MDX-C8900

SERVICE MANUAL

SUPPLEMENT-1

Subject: Main board Modification

2-4. SCHEMATIC DIAGRAM - MAIN Section (1/3) -

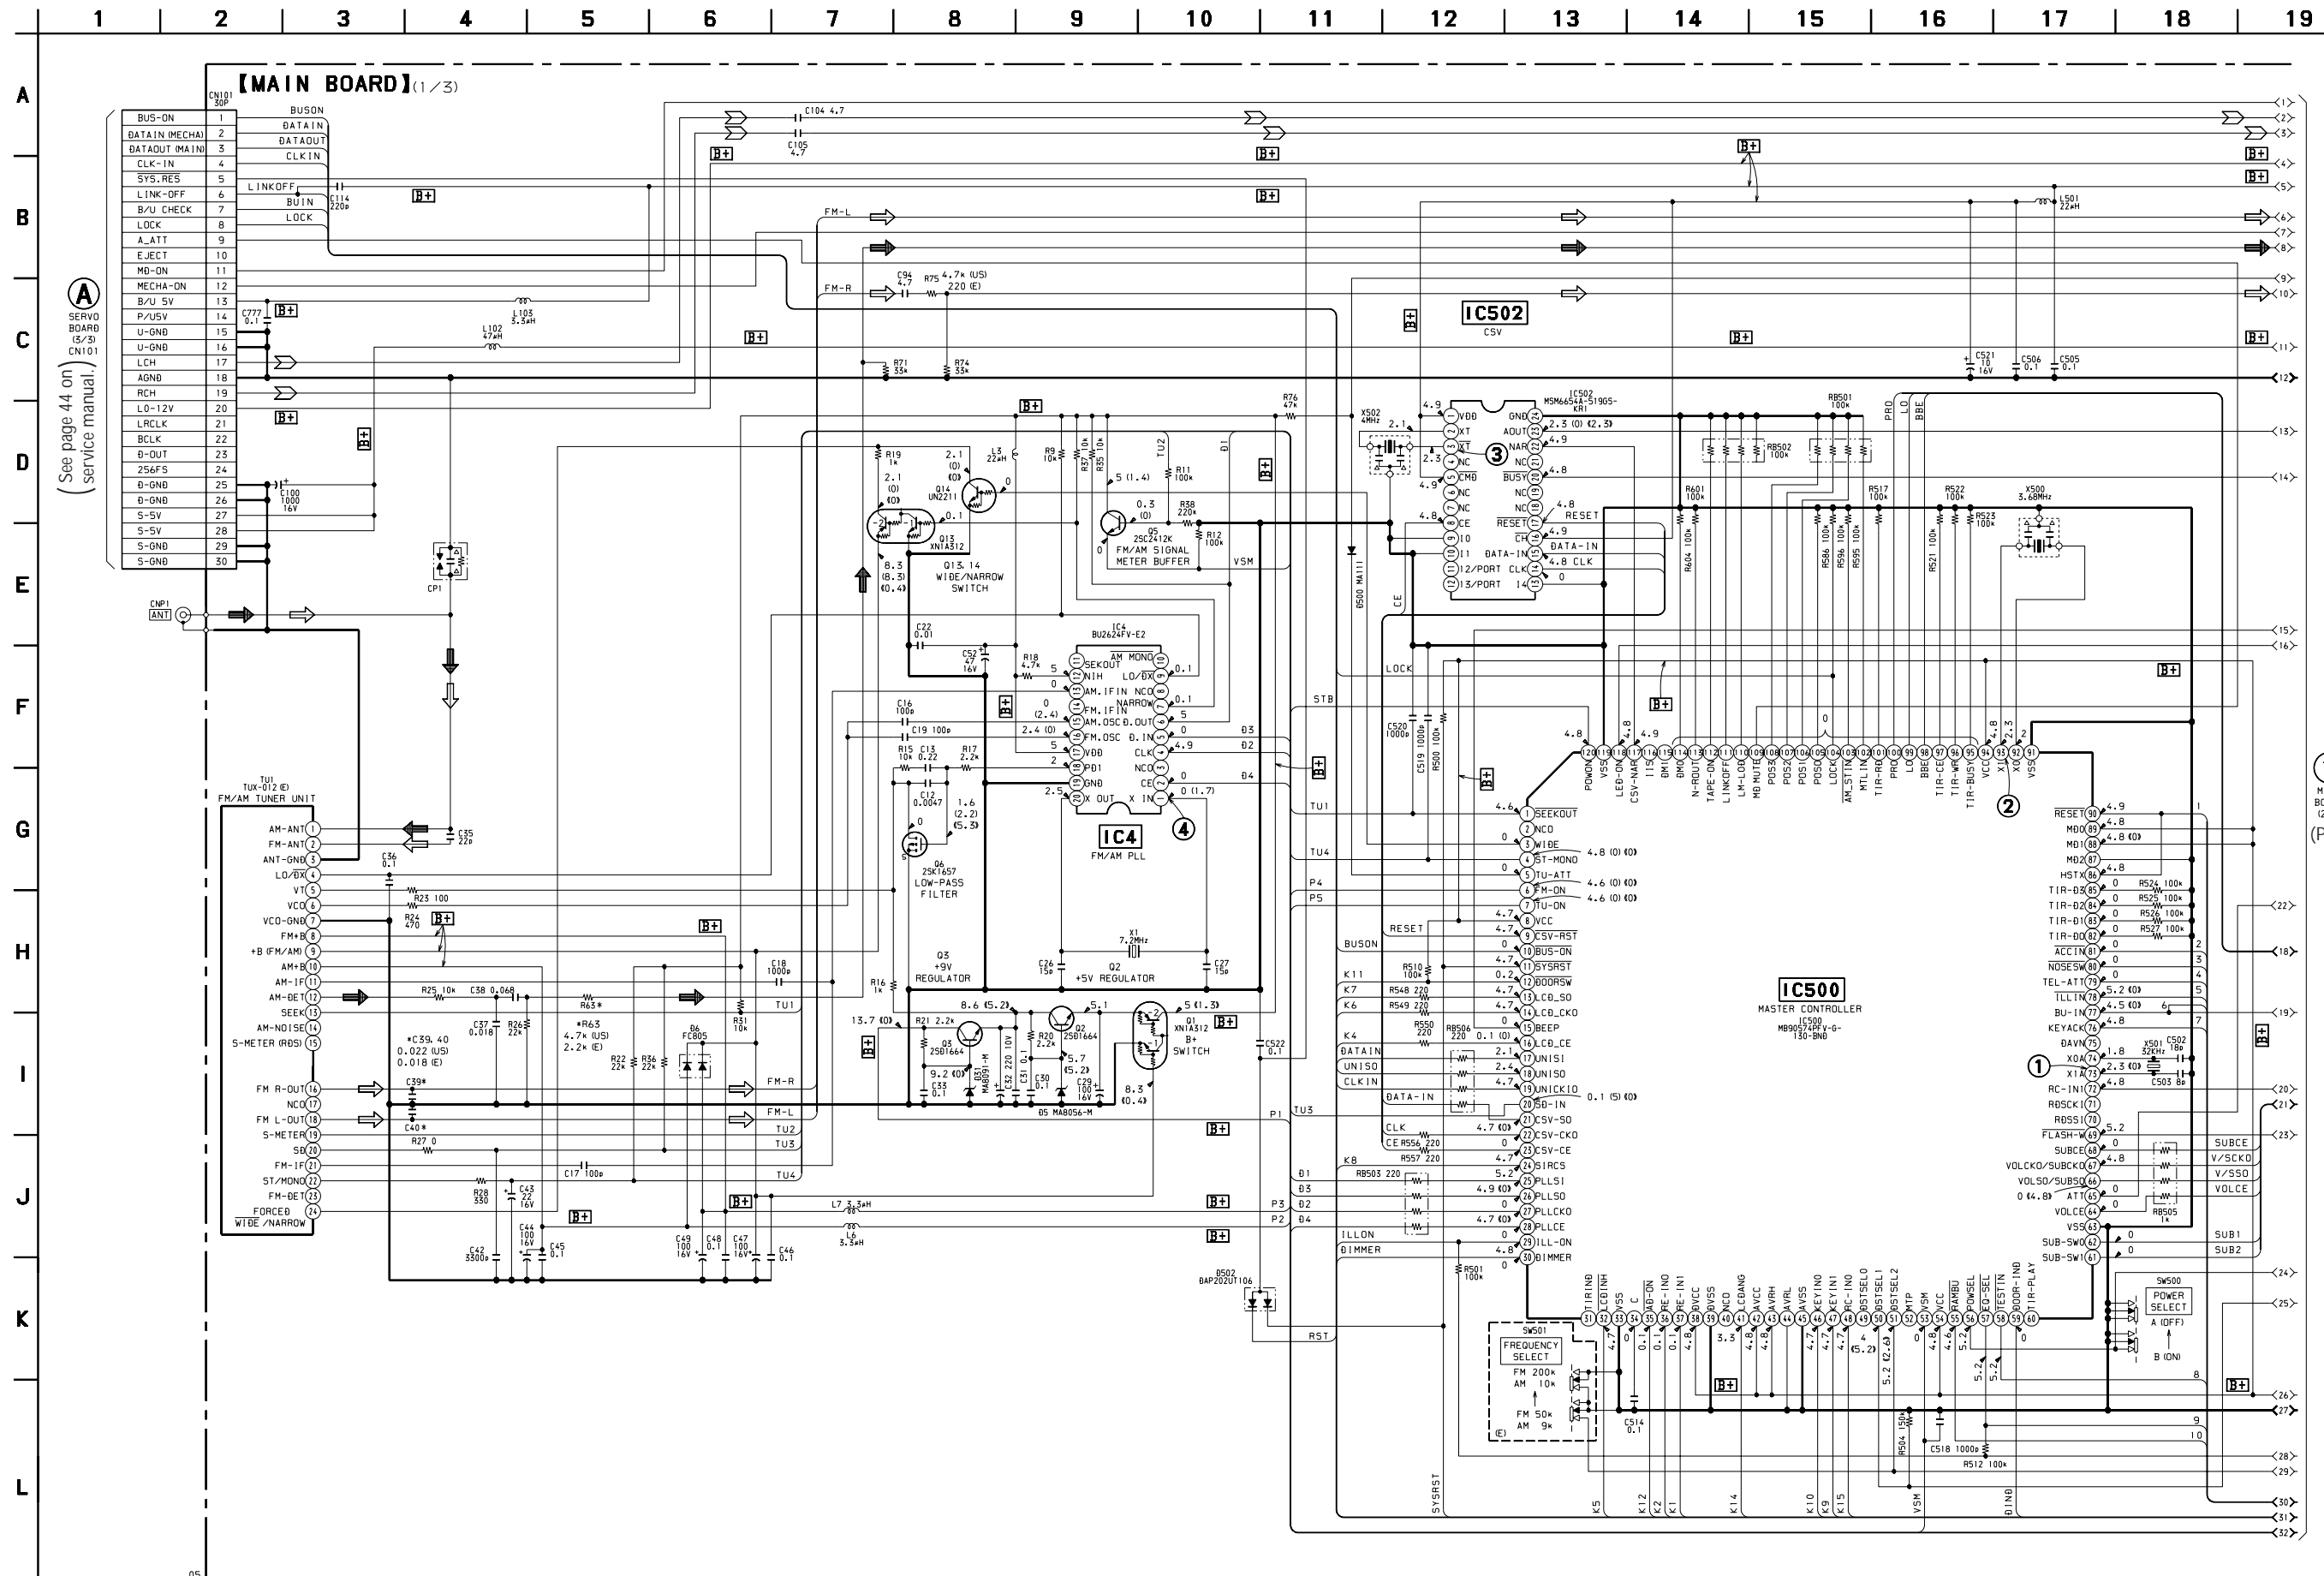
(ECN-CSB00088)
